London School of Hygiene & Tropical Medicine

Tavistock Place

**LEGEND (ALL CHANGES TO ALL LEVELS)**

TP2

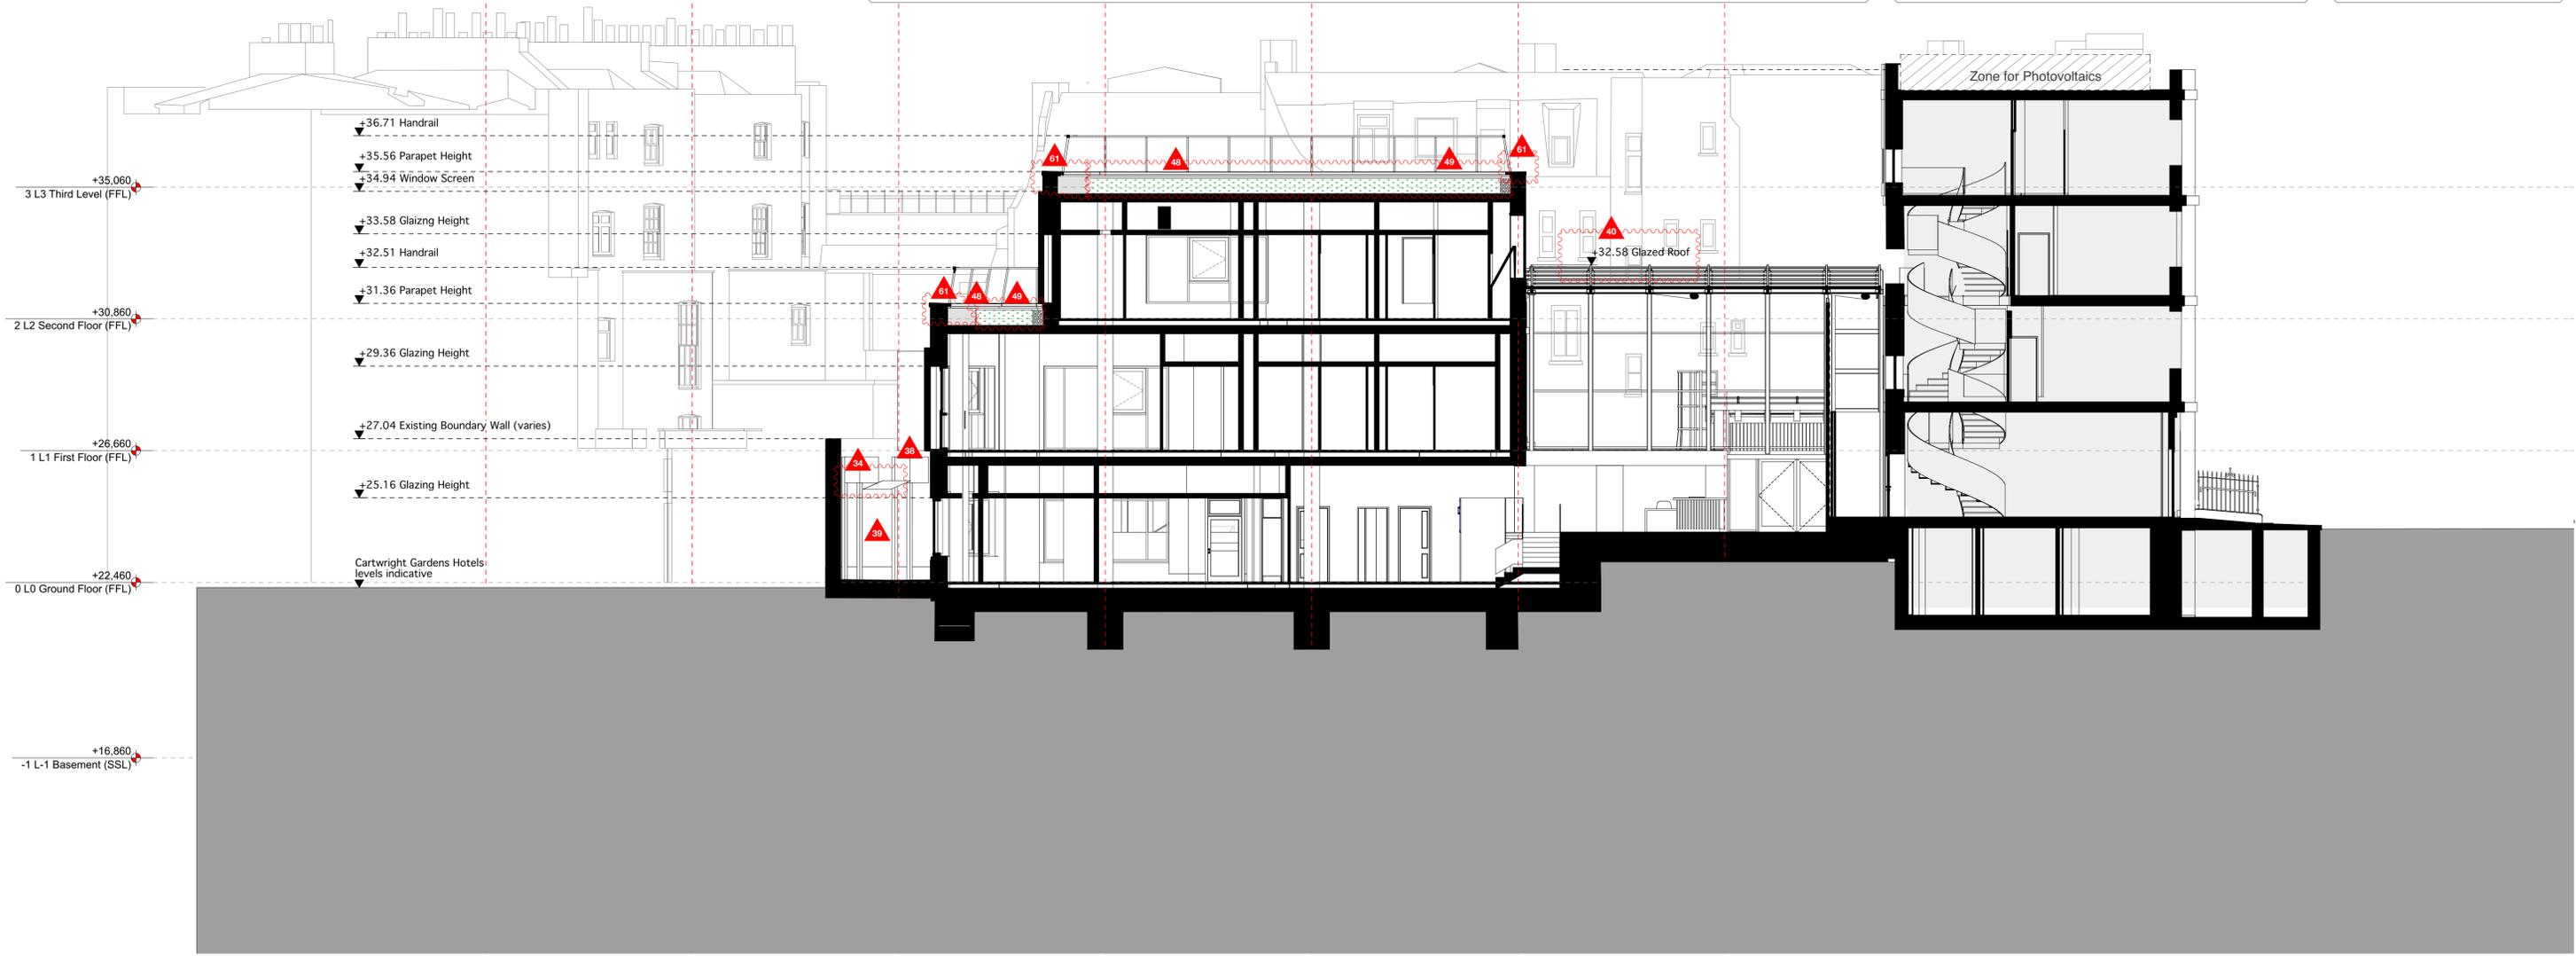
| ▲61 Stair 2 omitted, and glazed entrance enclosure enlarged               | ▲29 External ramp adjusted, and railings added.   | ▲18 Window on north elevation of TP2 reduced in length. | ▲29 Revised door design  | ▲46 Height of glazed entrance roof increased to suit required pitch. | ▲61 Orientation of brass seams adjusted                          | ▲92 Door to be replaced                              | ▲74 Red line extended to include new ramp and frontage  |
| ▲62 Window added  | ▲10 West stair core glazing fenestration adjusted to suit amended stair landing levels. | ▲10 Revised turn-table size and position                | ▲30 Modifications to windows, doors and facades facing into courtyard.             | ▲41 Glazed entrance roof and canopy revised                          | ▲62 Roof gutters revised.  | ▲63 Revised proposal for the entrance                | ▲75 Ladder added  |
| ▲63 New steps to base of external spiral stair                            | ▲11 External paving levels in courtyard raised to achieve required paving falls.        | ▲11 Entrance ramp gradient and levels adjusted.         | ▲31 Gate details revised   | ▲42 New roof guarding to existing flat roof                          | ▲63 Means of escape revisited and exit door added to TP1         | ▲64 Gates and Entrance door in TP1 to be replaced    | ▲76 Works to Mews paving/kerbs added  |
| ▲64 Stair 3 roof and gable end arrangement revised.                       | ▲12 Low brick plinth added to base of external walls to TP2.                            | ▲12 External levels adjusted                            | ▲32 Revised proposal for bike storage replacing existing bike racks in Dairy shed. | ▲43 Screening fins and cladding added                                | ▲64 Spiral staircase landings added at each floor                | ▲65 Existing stair to be demolished                  | ▲77 Minor adjustment to ridge, and eaves line, (not affecting ridge level noted on consented drawings). |
| ▲65 Level 3 accommodation mansarded                                       | ▲13 Brick plinth added to base of existing buildings within courtyard.                  | ▲13 TP1 west door ramp omitted                          | ▲33 Gate retained and modified   | ▲44 Louvres added  | ▲65 Door modified  | ▲66 Existing window and door to be replaced          |   |
| ▲66 Roof light size, height and position adjusted, and smoke vents added. | ▲14 New steps and landing outside room G1.  | ▲14 Fall restraint added                                | ▲34 Bike canopy detail revised (typical condition highlighted)                     | ▲45 Ramp omitted   | ▲66 Basement louvers to external metal staircase landings        | ▲67 New reconfiguration for new spiral stair and WC  |   |
| ▲67 Louvres omitted.  | ▲15 Bin store enlarged and repositioned.  | ▲15 Gates removed                                       | ▲35 Sub-station doors revised  | ▲46 Door removed and infilled  | ▲67 Revised proposal for mean of escape in TP1                   | ▲68 Staircase partially demolished                   |   |
| ▲68 Roof light size, height and position adjusted.                        | ▲16 Gallery passageway to TP2: finishes revised.  | ▲16 Maintenance access door added                       | ▲36 Steps adjusted   | ▲47 Access hatch adjusted.   | ▲68 Revised proposal for window and door                         | ▲70 Level adjusted                                   |   |
|   | ▲17 Gallery passageway; entrance gates design revised.                                  | ▲17 Parapet revised                                     | ▲37 Cladding changed to brass finish   | ▲48 Depth of green/blue roof build-up adjusted.                      | ▲69 Revised proposal for door to be left as current              | ▲71 Lift pit adjusted                                |   |
|   |   | ▲18 Roof/wall shape adjusted                            | ▲38 Wall mounted planters revised (typical condition highlighted)                  | ▲49 Blue roof incorporated into green roof and gravel margins added. | ▲70 Gate to be removed   | ▲72 Level updated                                    |   |
|   |   | ▲19 TP1 reception relocated                             | ▲39 Steel posts added to boundary wall (typical condition highlighted)             | ▲50 Cladding build-up adjusted                                       | ▲61 Capping width adjusted and roof planters shown indicatively. | ▲73 Red line extended to include South Crescent Mews |   |
